Attached please find additional correspondence that THINC requests be included with the public comments relating to PL-08-00370, Treasure Hill Conditional Use Application, Creole Gulch and Town Lift Mid-station Sites. I have also attached a copy of the slide presentation I used during the August 10, 2016 Planning Commission meeting, along with the slides that were presented by John Stafsholt at the same meeting. We request that both slide presentations be included with the public comments. Please let me know if you have any difficulty opening the attached files. Thank you.

Re: Treasure Hill Conditional Use Permit Application

I write on behalf of THINC, Inc., a non-profit organization comprised of hundreds of Park City residents, business owners, and home owners. This letter is intended to supplement and clarify my public comments at the August 10, 2016 meeting of the Planning Commission with respect to Project Number PL-08-00370, Treasure Hill Conditional Use Permit Application, Creole Gulch and Town Lift Mid-station Sites.

Building E – Lowest Levels – Current Claim

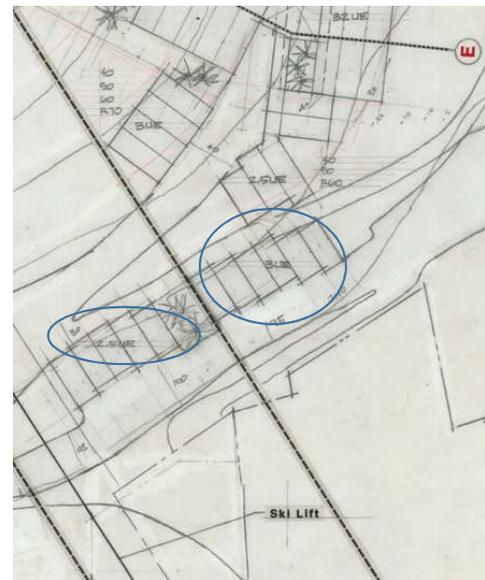
Woodruff UEs Do Not Add Up to Current Claims

North:
 L(-3) 2,972 sf
 L(-2) 2,972 sf
Total: 5,944 sf

South:
 L(-3) 2,602 sf
 L(-2) 2,602 sf
Total: 5,204 sf

Woodruff UEs Correspond to Current Claimed Square Footage

North:
 3 UEs
 3 x 2,000 = **6,000 sf**

South:
 2.5 Ues
 2.5 X 2,000 = **5,000 sf**
5,000 X 5% = 250 sf
5,250 sf

Building C – Current Claim

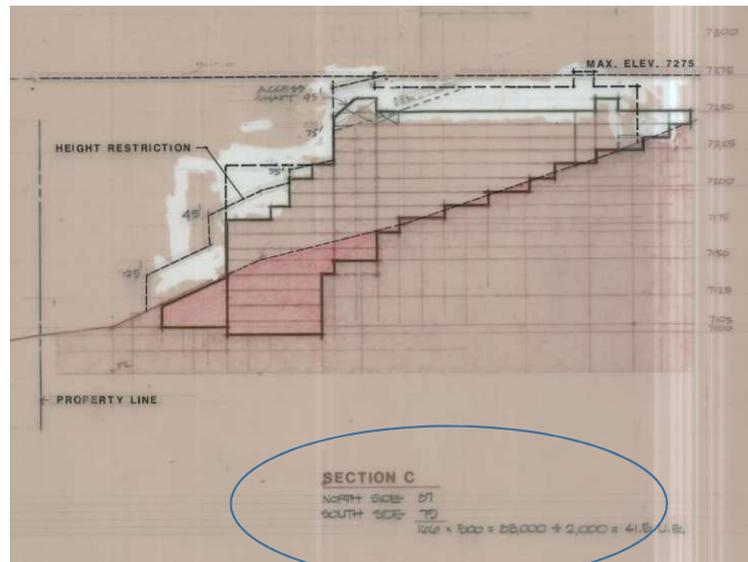
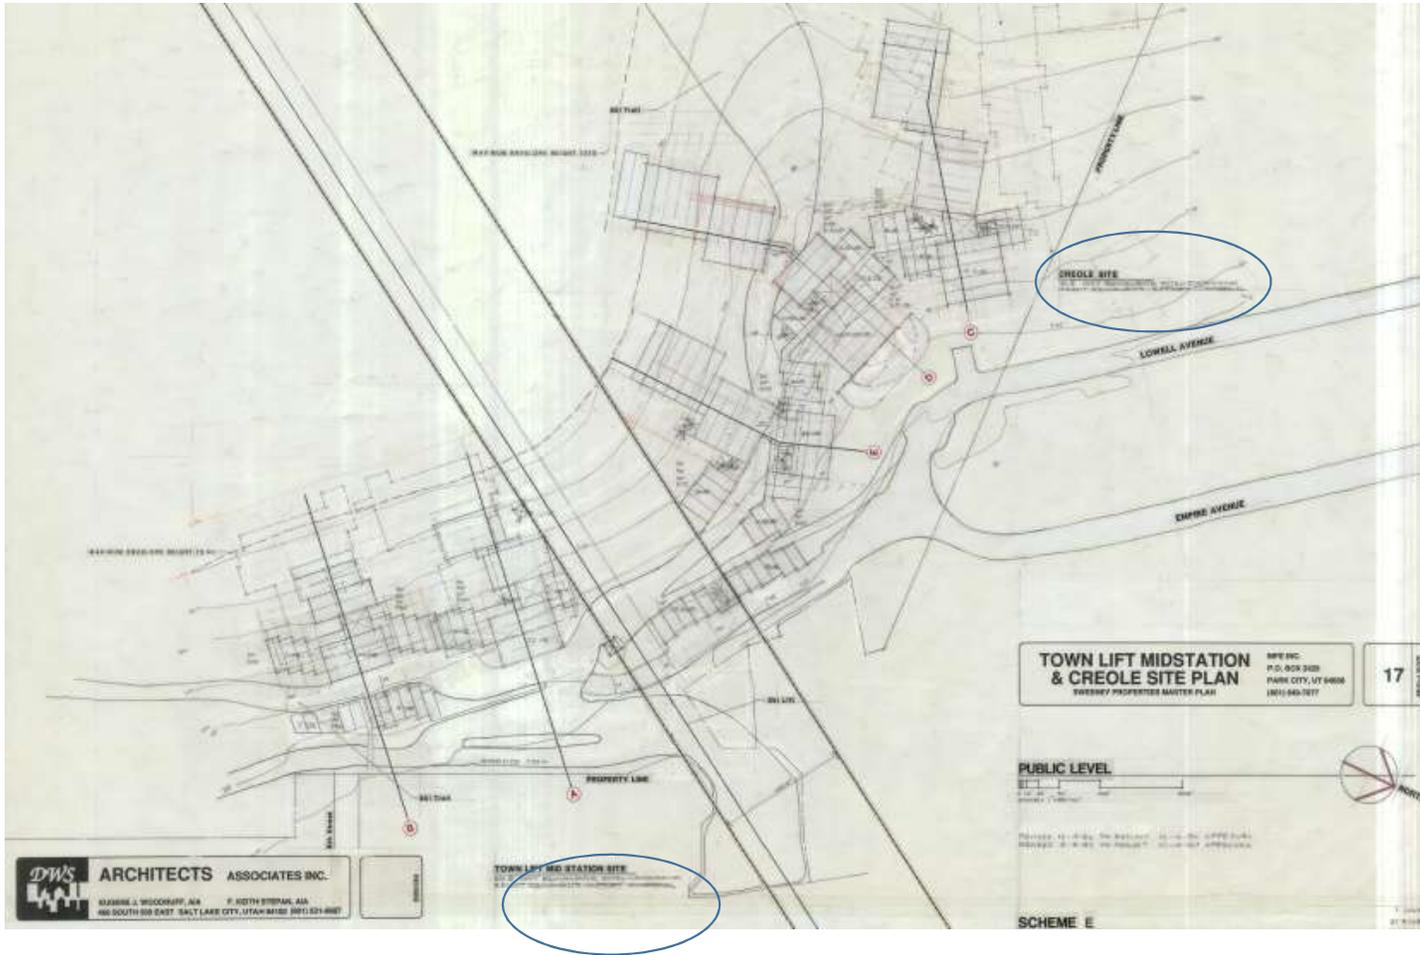
Exhibit Y Total:
154,406 sf

Original Woodruff Drawing Shows Far Less

North Side 87
South Side 79

$166 \times 500 = 82,000$ sf
 $82,000 \div 2,000 = 41.5$ UE

Add 5% = **92,400 sf**

1986 WOODRUFF CONCEPT

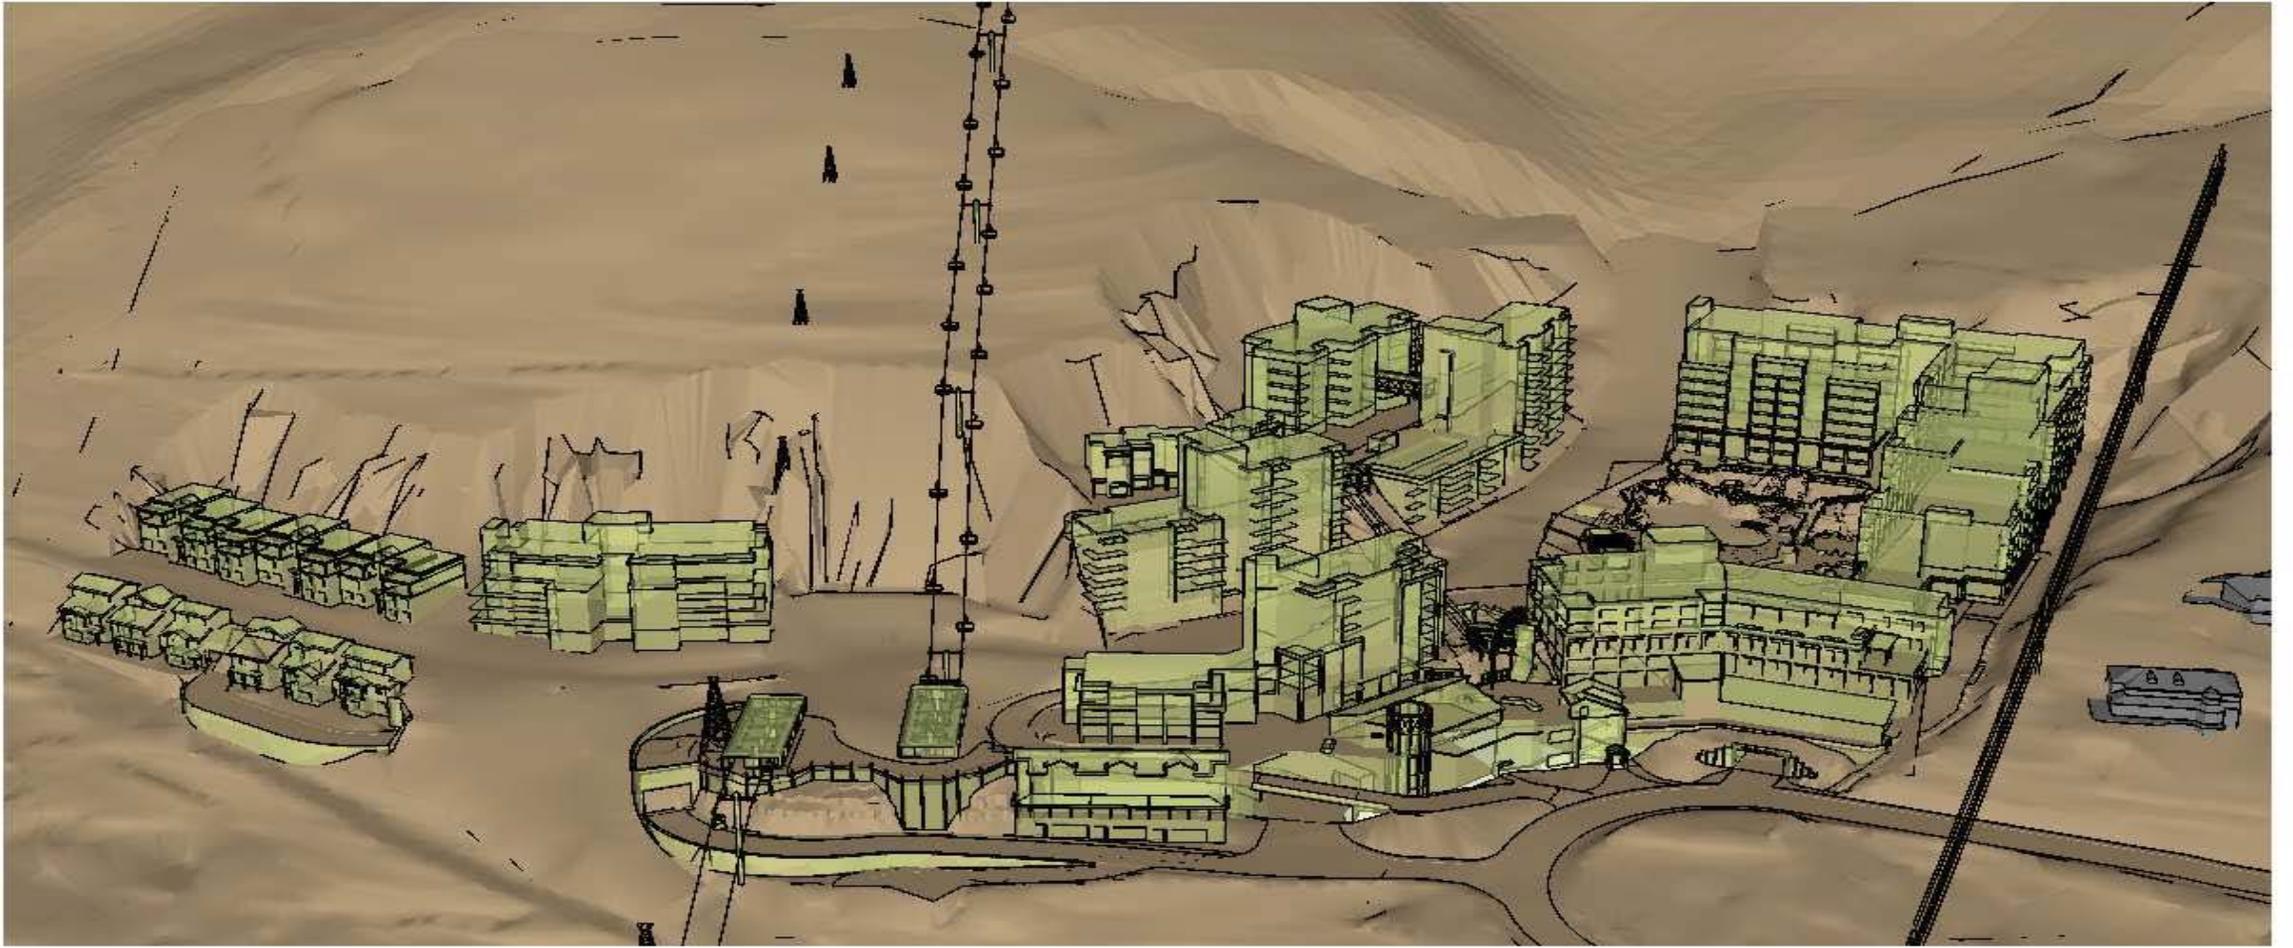
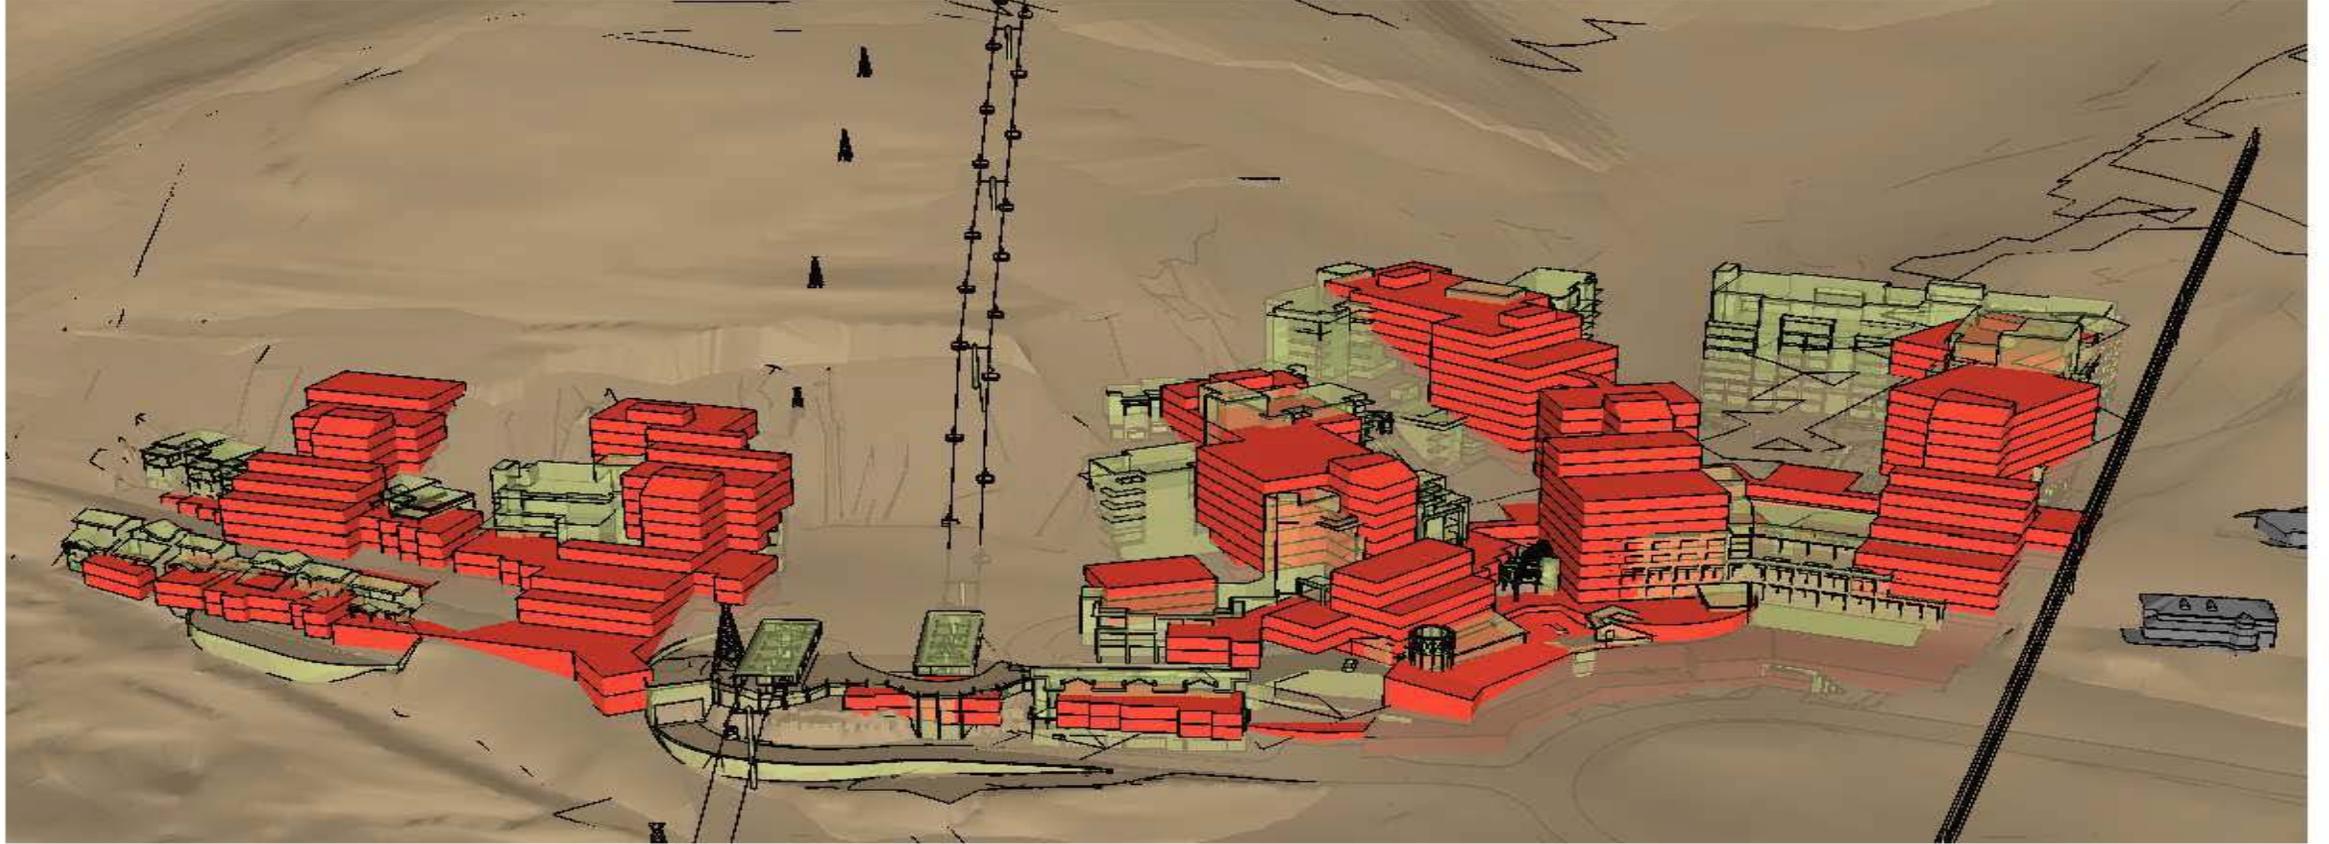
* Why are the Creole Gulch buildings with a maximum height of 75’ being submitted with 13 stories and over 140’ tall?

* Why are the Mid-Station buildings with a maximum height of 45’ being submitted with 7 stories & over 90’ tall?

1986 Concept drawings show project stepping up site
Buildings working with natural grade MPD site planning requirement LMC 15-6-7 (F) SITE PLANNING
“The project should be designed to fit the Site, not the Site modified to fit the project.”

1986 WOODRUFF CONCEPT & 2009 TREASURE CUP

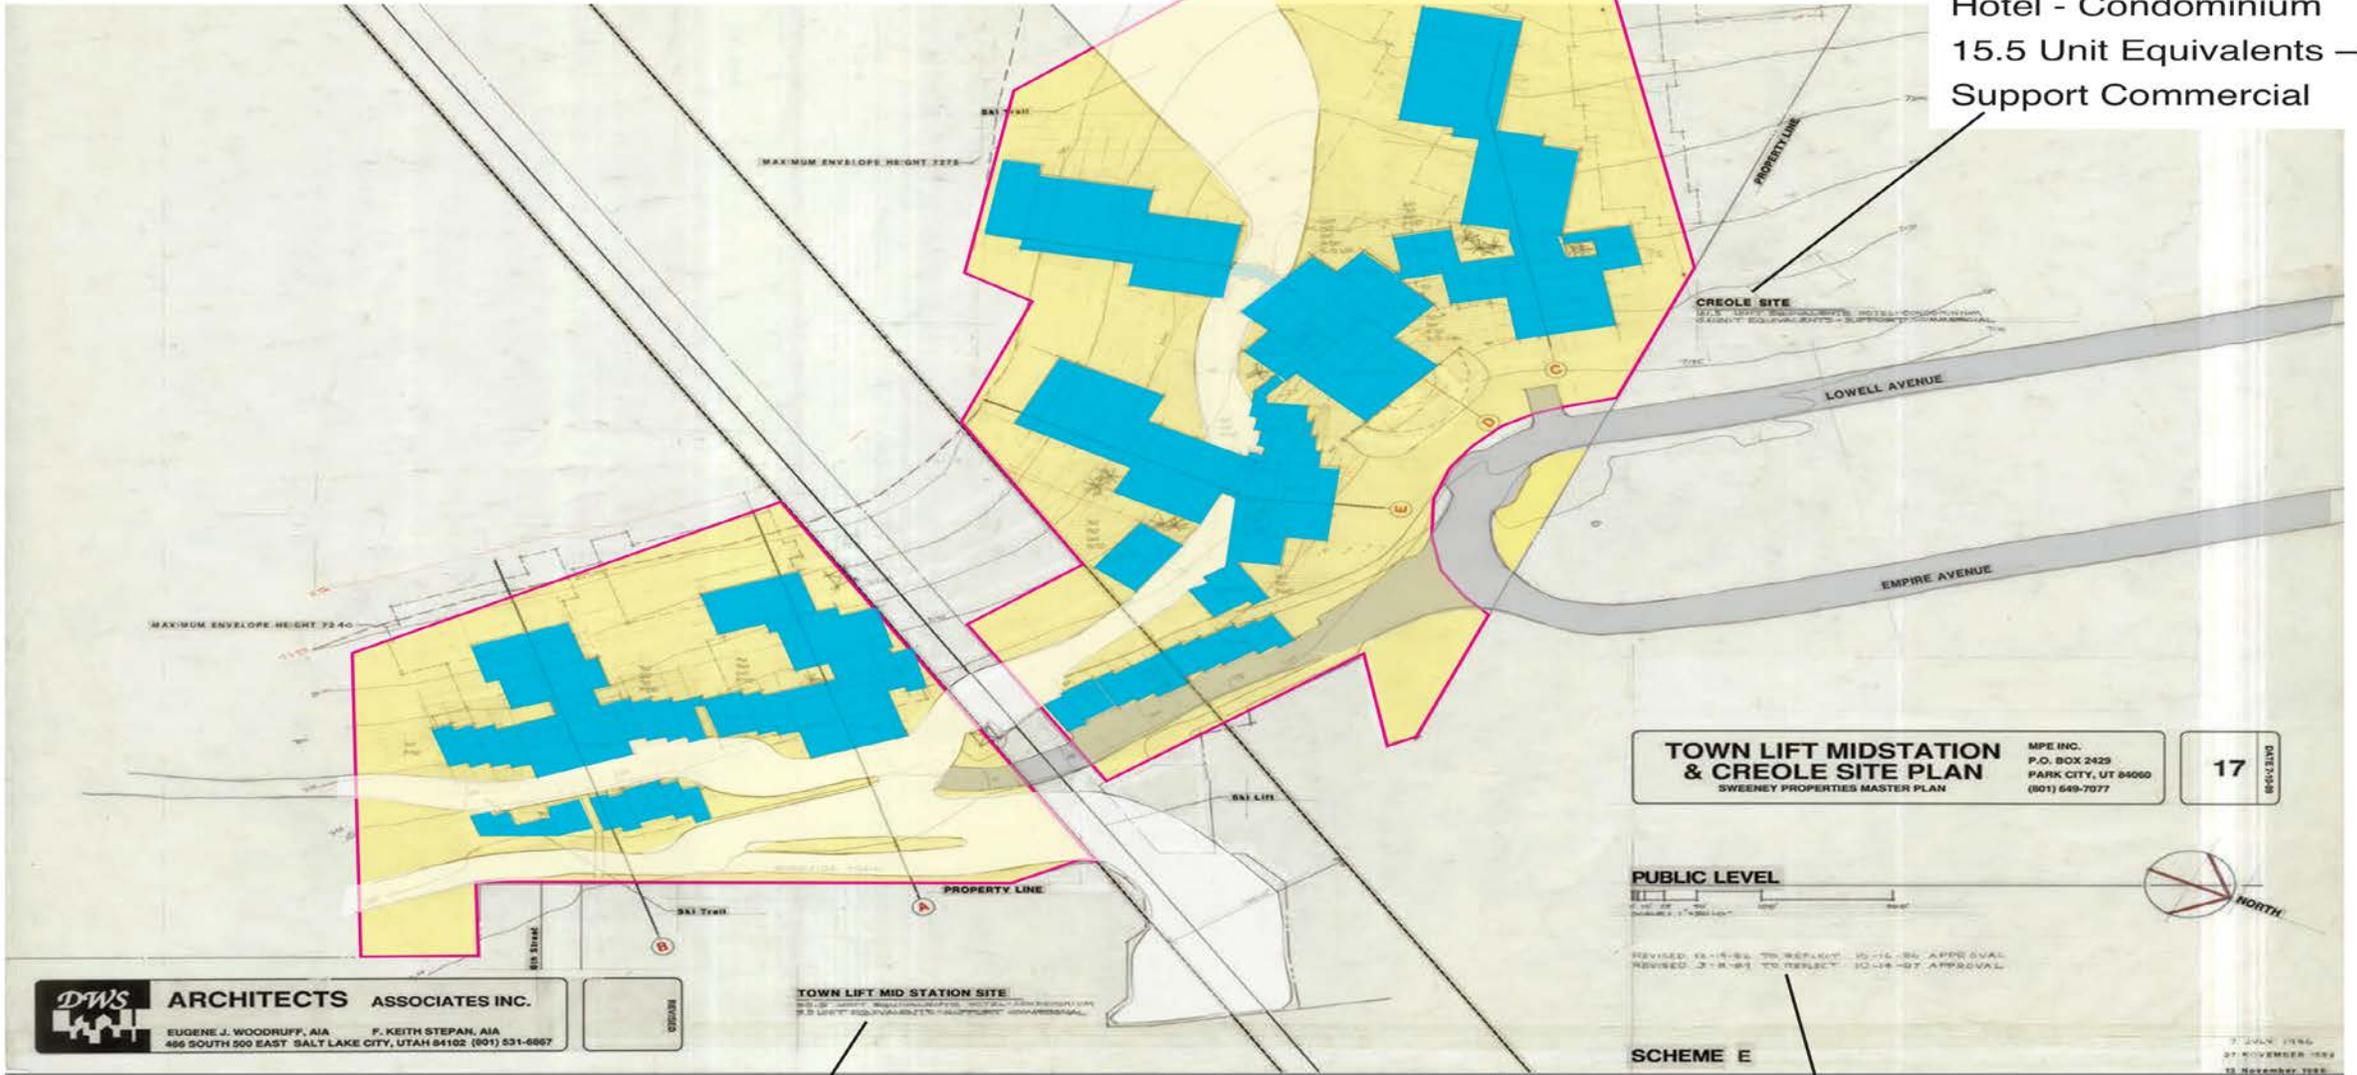
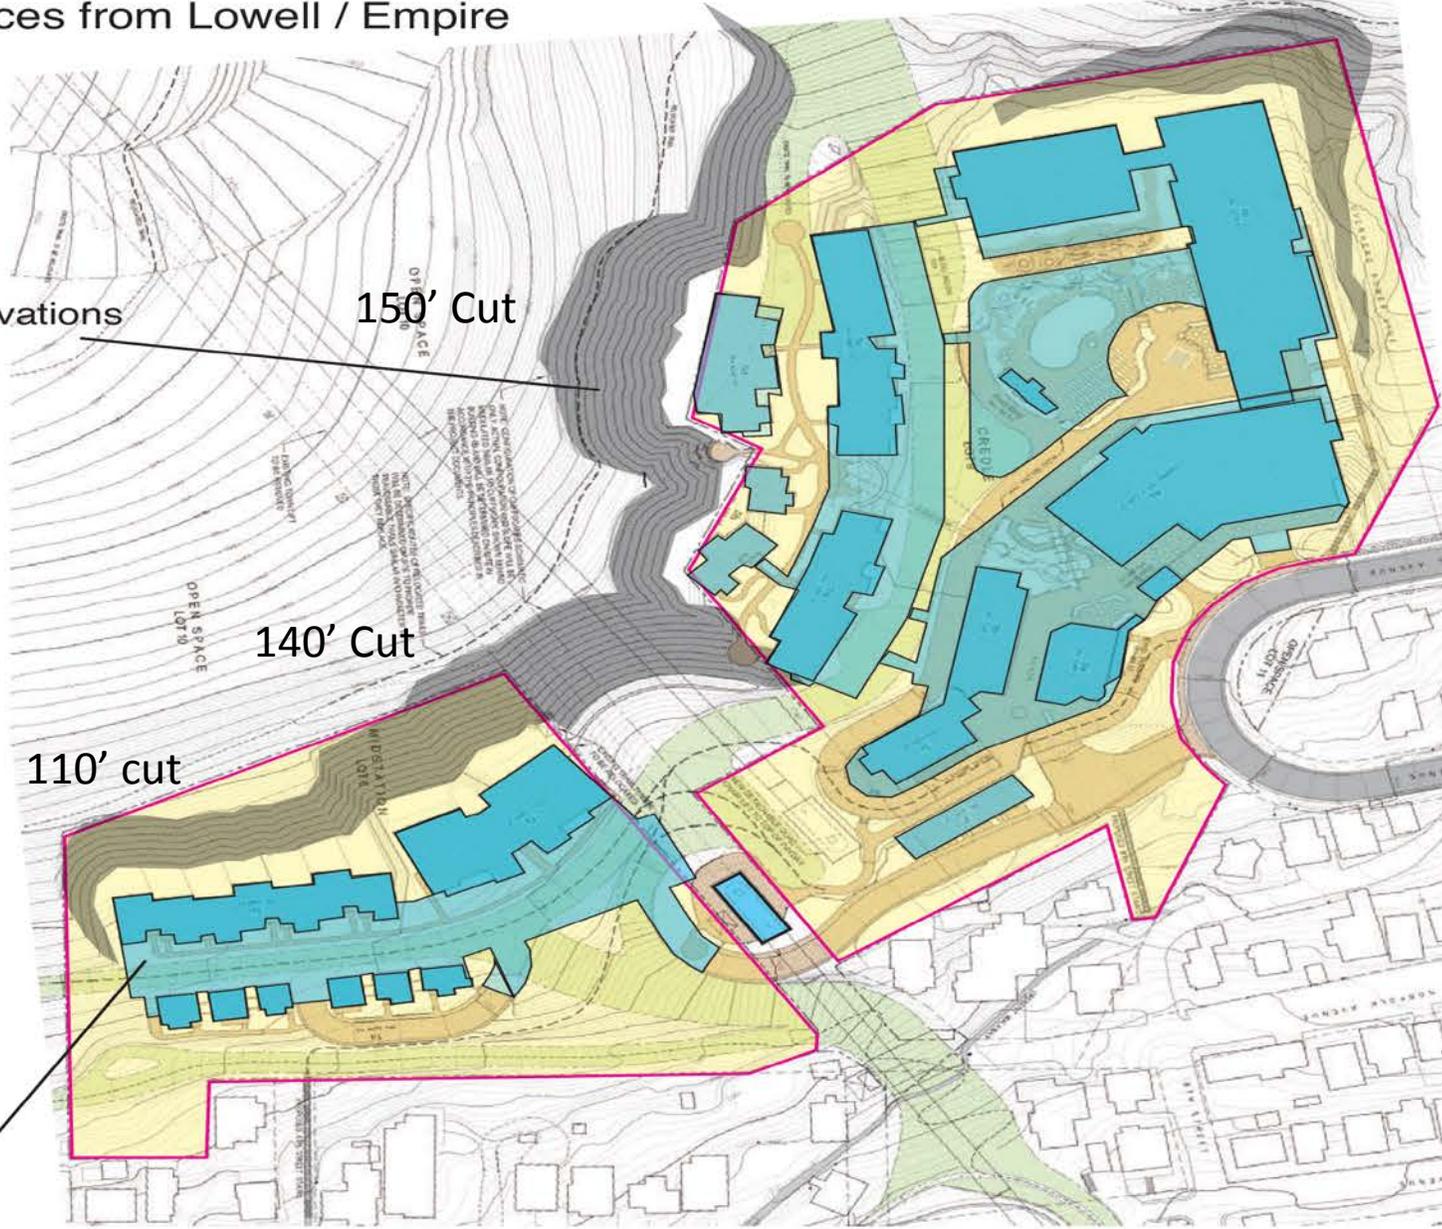
1985 / 86 Approved Site Plan, Footprints and Density
 Buildings work with the natural grade – No excavated hillsides
 Only Two entrances from Lowell / Empire

2004 Expanded Project — More than twice the approved square footage

Massive hillside Excavations

Four entrances from Lowell / Empire

145' Cut

150' Cut

140' Cut

110' cut

11.5 acres in Old Town
Every tree, bush, blade of grass gone.
Excavation of entire zone of at least 20'.
